6B KEY TELEPHONE SYSTEM "DIALOG*" INTERCOM SYSTEM

1.001 This addendum supplements Section 518-411-100, Issue 2. Place this pink sheet ahead of Page 1 of the section.

1.002 This addendum is issued for the following reasons:

Fig. 5—Modification of Key Telephone Sets for Use With 6B Key Telephone System (Sheet 6 of 6)

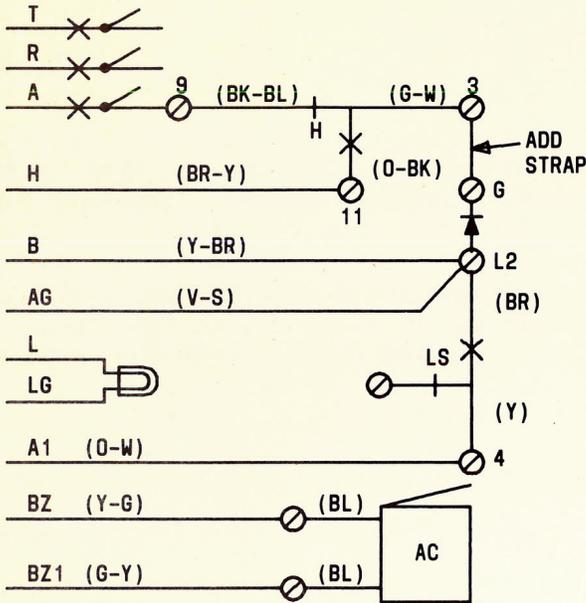
2.004 On Fig. 5, sheet 6, the following changes are made and the old Fig. 5, sheet 6 is obsolete. A new Fig. 5, sheet 6 is provided in this addendum. Changes are:

- (a) Color of lead from terminal 9 to break contact of H key is added (BK-BL)
- (b) Color of lead from terminal 3 to swinger of H key is changed from (BK-BL) to (G-W)
- (c) First and fifth spares in table associated with 851/2851CM telephone set are deleted
- (d) Title of drawing and table are changed from 851/2851 to 851/2851CM telephone set.
